CULTURAL RESOURCES OFFICE PRESERVATION BOARD

REGULAR MEETING

MONDAY – APRIL 25, 2016 — 4:00 P.M.

DATE: April 25, 2016
ADDRESSES: 2415-17 S. 7th Boulevard and 721 Victor Street
ITEM: Demolitions of 2403, 2405, 2415-17 S. 7th Boulevard and 721 Victor Street and construction of an apartment building at 2415 S. 7th Boulevard
JURISDICTION: Soulard Local Historic District; Soulard National Register Historic District Ward 7
Staff: Betsy Bradley, Cultural Resources Office

PROPOSED NEW APARTMENT BUILDING AT CORNER OF VICTOR AND S. 7TH BOULEVARD

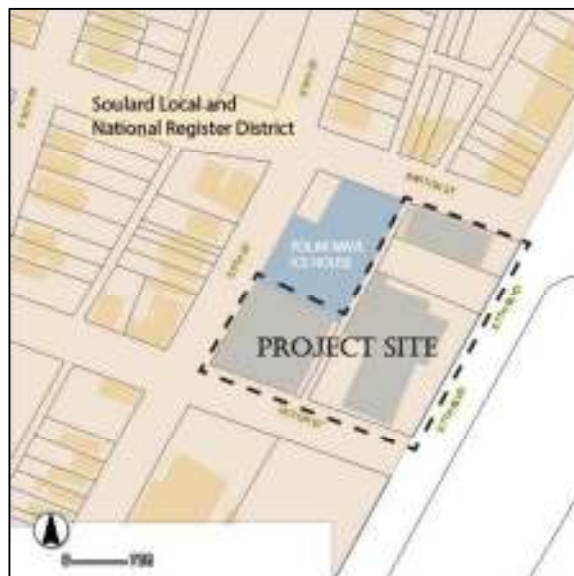
Whistler One L.L.C. has provided copies of contract for the purchase of four parcels at 2403, 2405, and 2415-17 S. 7th Boulevard and 721 Victor Street that it proposes to redevelop. The project would entail the demolition of a number of small warehouses and industrial structures: two buildings on the Victor Street property, one a Merit building and the other non-contributing, being constructed after both 1929, the date used in the Soulard Neighborhood Local Historic District Standards for the end of historic significance, and 1941, the cut-off date for contributing resources in the Soulard National Register Historic District; 2415-17 S. 7th Boulevard, Victor Iron Works, consisting of small buildings along S. 7th and a storage yard with a structure supporting traveling cranes at the corner of S. 7th and Victor Street, and another yard on the north side; and a Merit building at the corner of S. 7th and Barton Street. The new building proposed to replace them would be a five-story apartment building of 118 units with 59 on-site parking spaces.

Complies with Alignment and Setback. The new building will be set at the sidewalk line along S. 7th, as is the building at the north corner. Along Victor, which intersects S. 7th at an angle, the building occupies the entire blockfront and stays close to the sidewalk with incremental setbacks.

The massing of the new building does not introduce any significant new height to the district. The architect calculates that the proposed building would be approximately the same height as the taller portion of the Polar Wave complex on the same block. The significant grade change between S. 7th and S. 9th reduces the visual effect of the overall height of the building, as not all of the lower story would be above grade near S. 9th Street. The four stories of brick and slightly set-back top story of a different material would visually diminish the effect of the five stories. The Humboldt School rises four stories above grade, as visible from Victor, and has two towers above that height. The two-story buildings on the west side of S. 9th have raised basements and parapets that provide some additional height to the residences. The flat roof the proposed building would be consistent with the flat roof of the Polar Wave building.

The building would be of a larger scale than is common in Soulard. The east façade of the building would face S. 7th, a wide boulevard street. As Humboldt School and its parking lot dominate the block to the south on S. 7th and a large multi-family residential unit is at the south end of the S. 7th blockfront to the north, the proposed building would not be a stark contrast in scale to any buildings other than those on the west side of S. 9th, which it would not face. The building is held back from the corner of Victor and S. 9th Street so that its taller height would not be as close to the historic buildings. An entrance to the parking lot would separate the new building from the approximately two-story portion of the Polar Wave site.

Two colors of brick are proposed for the street facades. The foundation material is yet to be selected. The color of the set-back fifth story is seen to be more important than the actual material; it will be neutral in character, and a material that may be painted an appropriate monochromatic color.

that the Preservation Board approve the demolition of existing buildings and structures and grant preliminary approval to the proposed new construction.

S. 7th FAÇADE

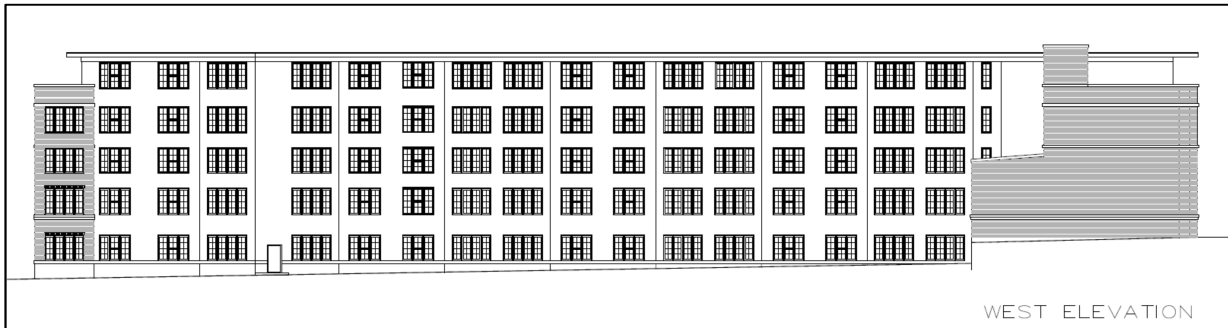
Complies in that the ratio is based on the Model Example. The ratios on the block and nearby buildings vary somewhat: from the windowless portion of the Polar Wave property to the north wall of the Humboldt School. The window openings will be filled with sash comparable to industrial steel sash; some units will have sash that fold back to create an inset balcony, rather than projecting elements of this type.

SIDE ELEVATION OF 2212 SHENANDOAH
WITH BRICK GABLE

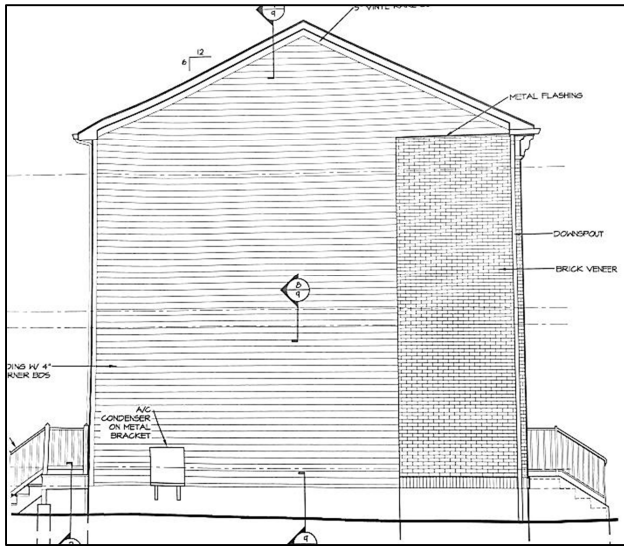
That the Preservation Board grant preliminary approval for the new construction, with the stipulation that the visible side elevations of 2212 and 2230 have full brick gables; that the remaining side elevations have additional gable trim, and that final drawings, materials and colors be reviewed and approved by the Cultural Resources Office.

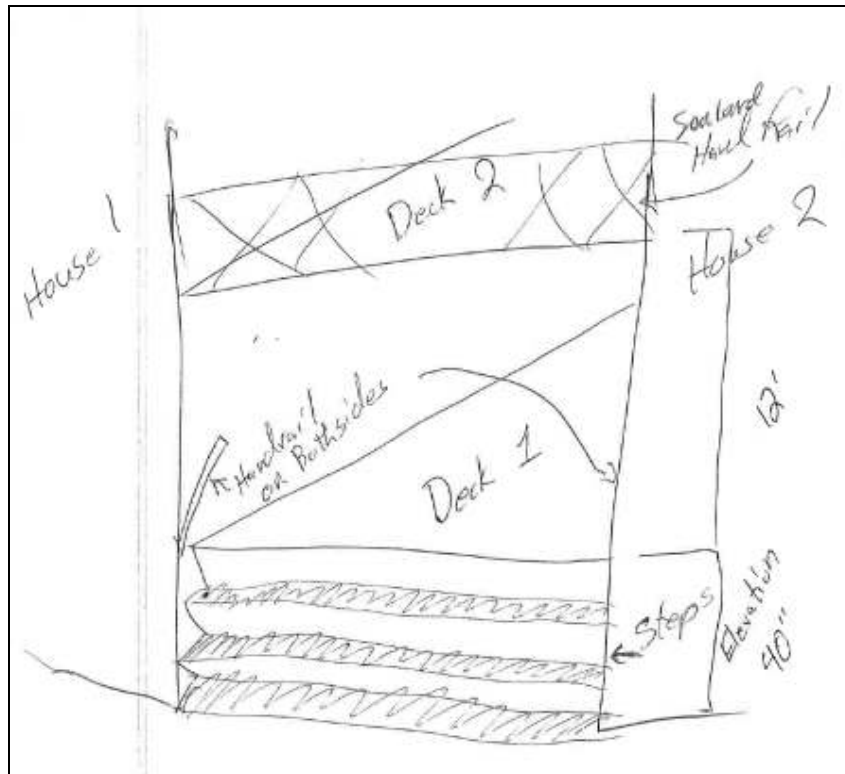
Partially complies. Although the plans lack detail and do not indicate materials, the owner has stated that it will have a Soulard-style handrail and will be stained or painted.

- 1303 Sidney Street is located in the Soulard Local Historic District.
- The owner proposes to construct a two-story deck to extend between the buildings at 1301 and 1303 Sidney St. The deck would also extend to the building line.
- The proposed deck is not a reconstruction of the existing porch and is not based on a Model Example as required by the Soulard Historic District standards.
- The submitted plans do not provide enough information to evaluate the plans for use of appropriate materials and design details.
